Review 1
Preliminary and Final Major Site Plan
w/Variances
Quattro Amici, LLC
(P-24-011)

Block 121, Lot 25
585 Avenue E
Transit Development District (TDD)

Prepared for the City of Bayonne by:

May 8, 2024

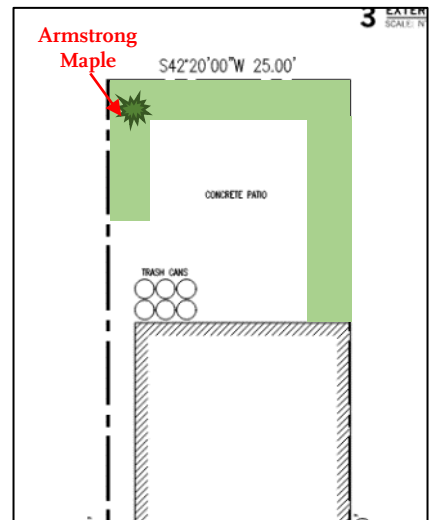
- 3.1.1. **Vehicular.** The site does not contain vehicular access.
- 3.1.2. **Pedestrian.** Access to all of the units is through the front façade located on Avenue E. The existing units are accessed via the southernmost entrance which has two steps leading into the building. The proposed basement studio will be accessed via new masonry steps, which are adjacent to the existing steps, and are proposed within the right-of-way. A concrete walk is located along the southwesterly side lot line which contains steps and leads to the rear yard. **As a condition of any approval, the applicant should receive approval for this protrusion into the right-of-way from the Municipal Council.**

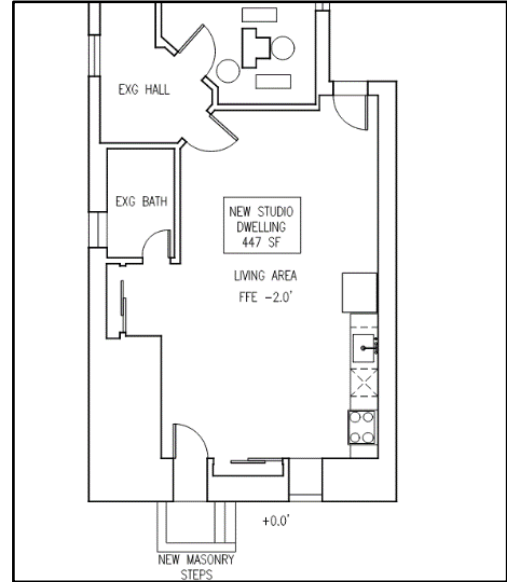
- 3.4. **Proposed Interior Modifications.** The plan proposes modifications to the basement. An existing recreation area is being converted to a studio apartment with access to Avenue E from a proposed masonry staircase. The site will also have access to the first floor from a hallway and staircase leading upstairs within the building. As indicated in the image included to the right, the studio will contain one room with living and kitchen space and will utilize an existing bathroom. The space has two windows and access to the concrete court yard. **The applicant should testify as to whether this bathroom already is, or will be converted to, a full bathroom as this will be required for the dwelling.**
